RE: Arboricultural Comment on Amended Crossover on Rawson Avenue: 13-16 Rawson Avenue (Drummoyne Reservoir) Drummoyne (LEC Case # 2020/00306306 Mike & Shan Pty Ltd V City of Canada Bay Council)

Ref: 2636(L)ArbComment

Screenshot from *Floor Plan – Level 1, SK/A02.04, Issue D* dated 22.2.21 showing proposed edge matching existing adjacent to Tree 2.

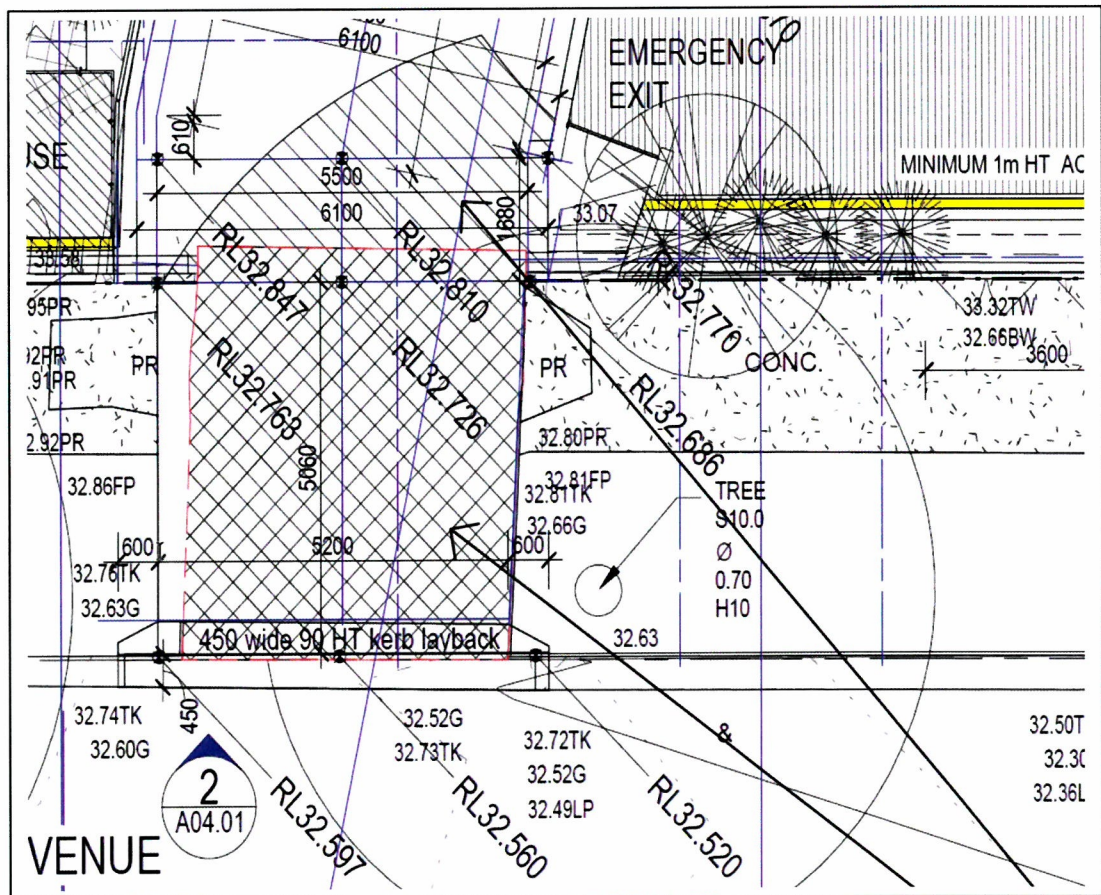
2.2 I have been provided with an amended Drawing being *Floor Plan – Level 1, SK/A02.04, Issue D* dated 22.02.2021 (Attachment A). This Plan shows (screenshot below) the proposed Driveway, crossover and layback overlaid with the existing Survey features. This drawing shows the proposed Driveway coinciding with the existing edge (in red) closest to Tree 2, with a narrow widening to the west away from Tree 2. The cross-hatched area is the existing Driveway. This represents new-for-old construction adjacent to Tree 2 and there should be no impacts on tree roots. Review of the Detail Survey shows that the new Driveway RLs match the existing Driveway RLs.

If the new works coincide with the existing there should be no impacts on the tree roots from Tree 2. A particular Consent Condition should be provided to detail the tree protection requirements during demolition and construction. The new Drive is to be no thicker than that existing. Particular Engineering comment is to be provided to strengthen the construction.

- 3.1 There is no requirement for root mapping adjacent Tree 2 as the proposed Driveway edge adjacent Tree 2 is now proposed to coincide with that existing.
- 3.2 The requirement for root investigation and reporting at 2.3 of the SOFAC should be deleted.
- 3.3 A Consent Condition is recommended that a Tree Management Plan be prepared by an AQF Level 5 Arborist for CC documentation detailing the tree protection measure required for demolition of the existing Driveway and construction of a new-for-old Driveway adjacent to Tree 2.

Attachment A: SK/A02.04 Issue D - Floor Plan - Level 1 by Milton Architects

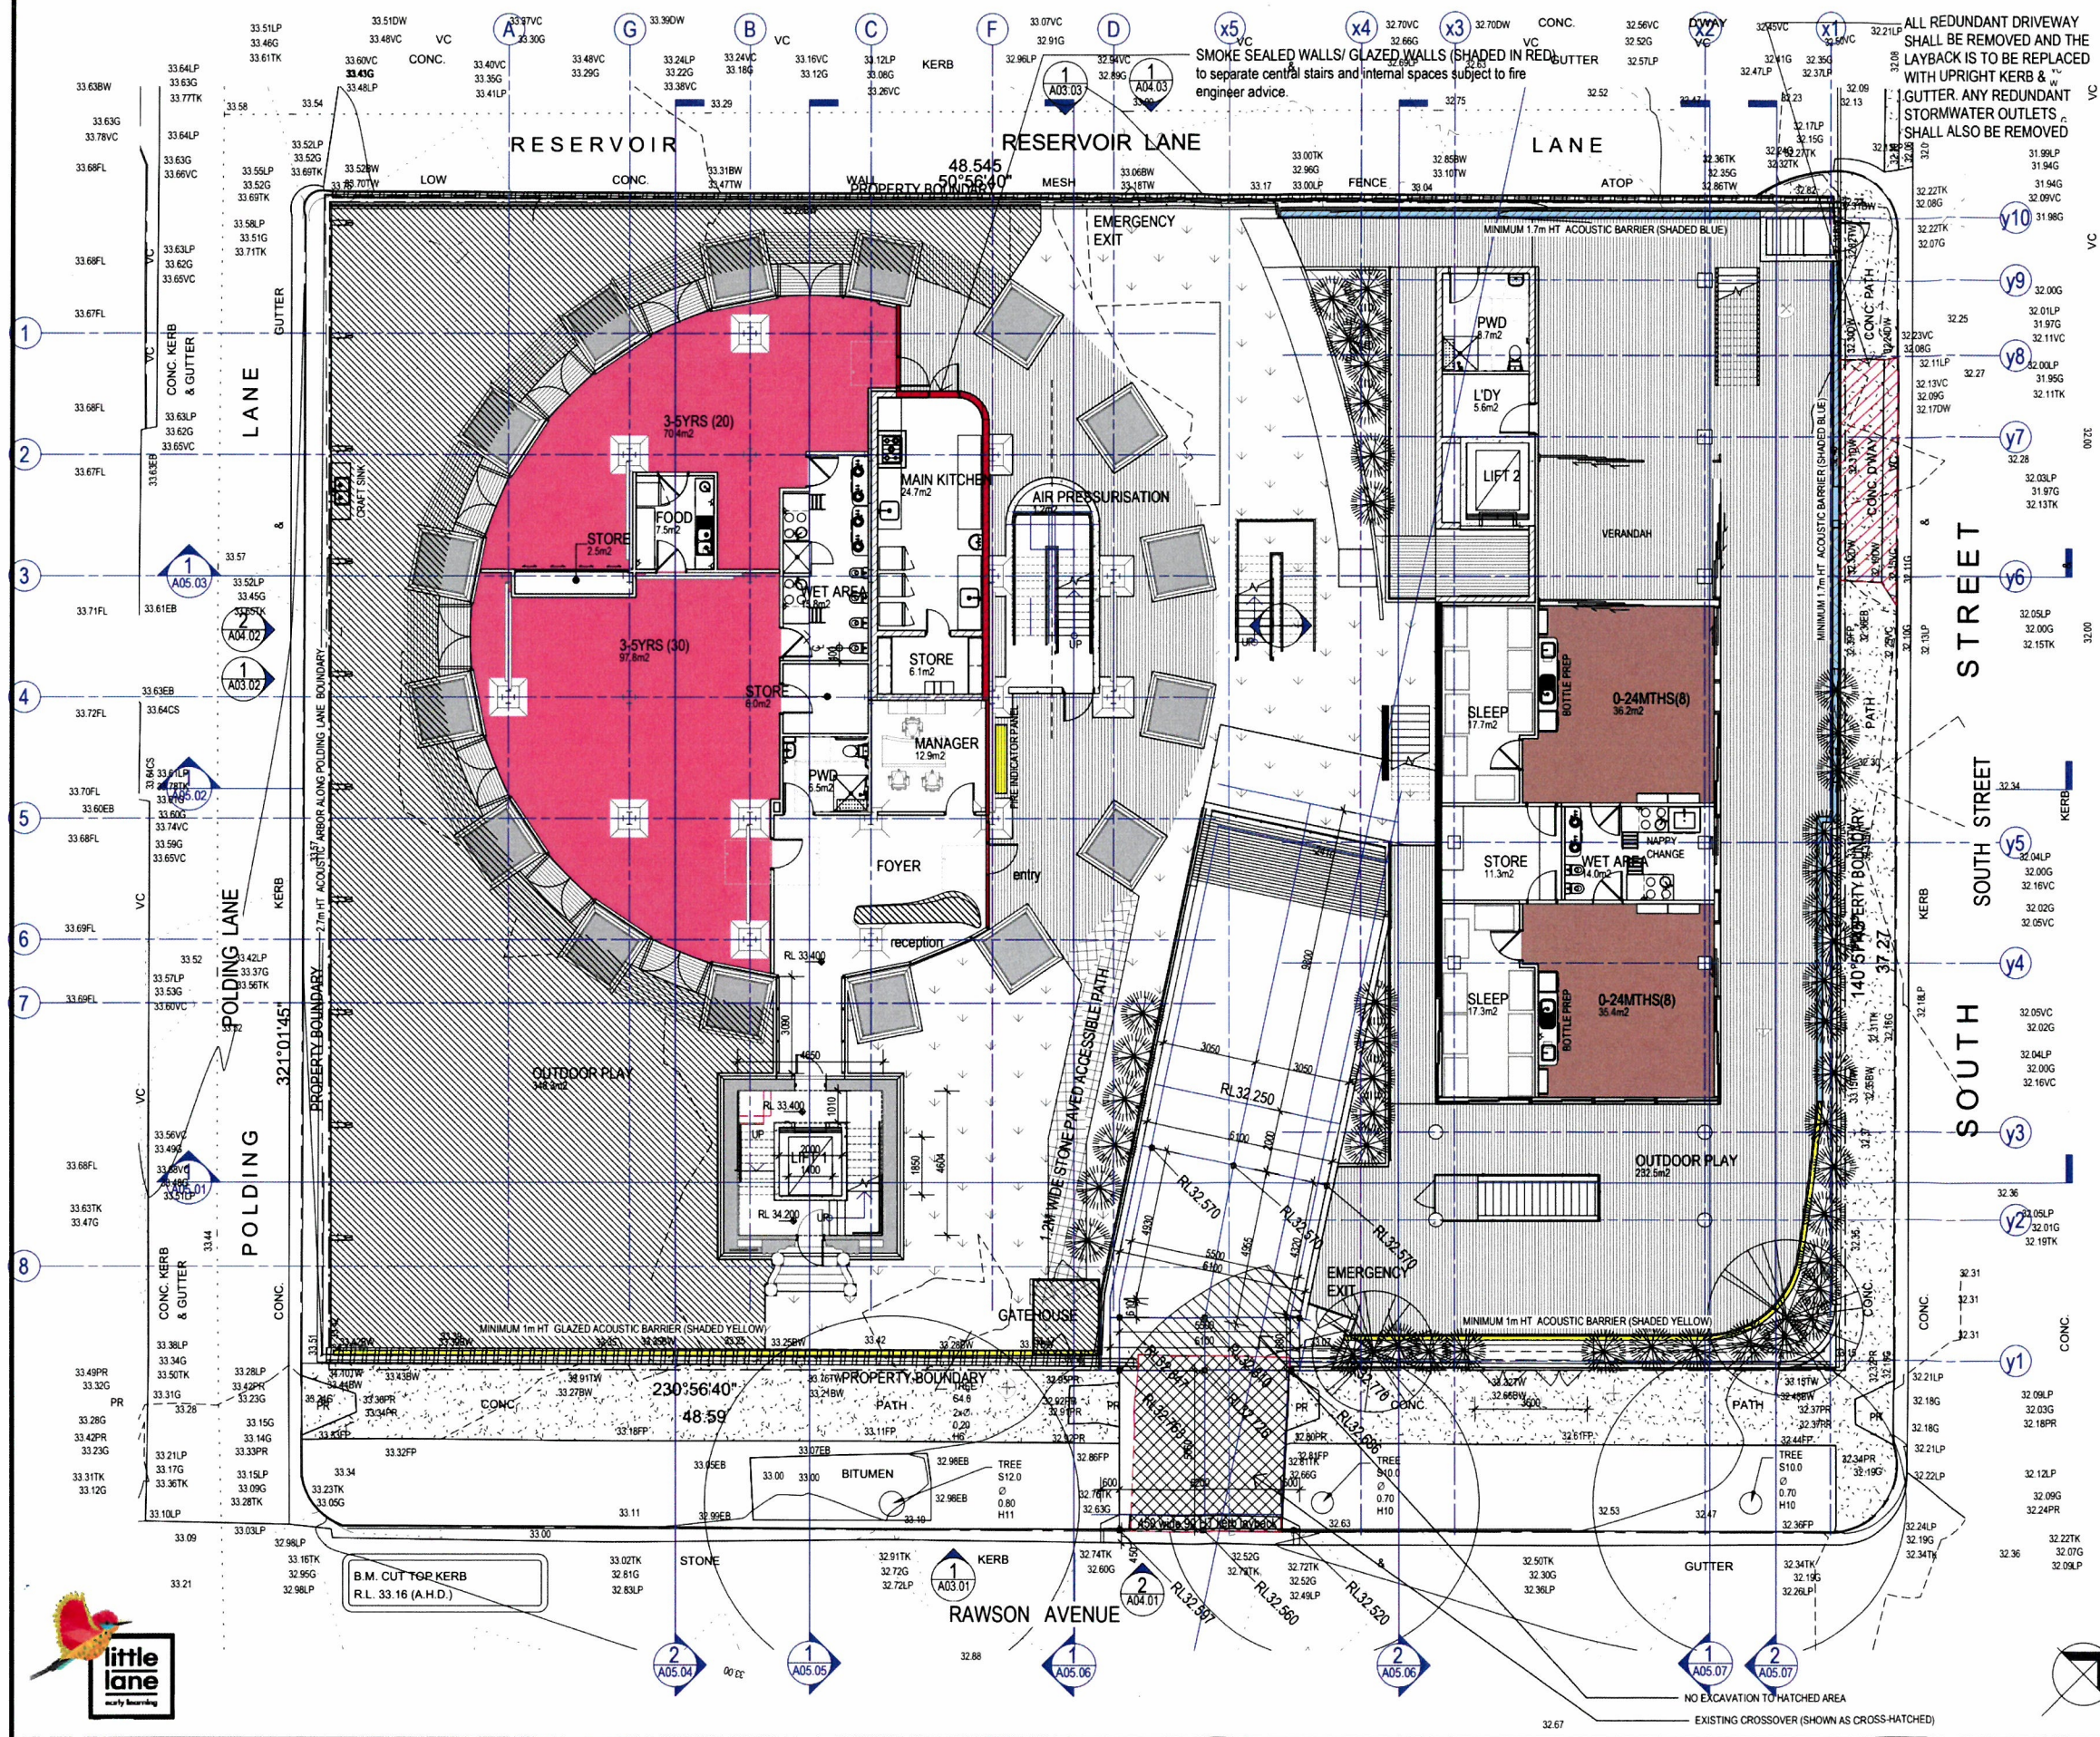
- 2.3 The Driveway is to be widened on the south-western side towards the other street tree, Tree 1. This widening towards Tree 1 represents a minor encroachment only into the Tree Protection Zone of Tree 1.
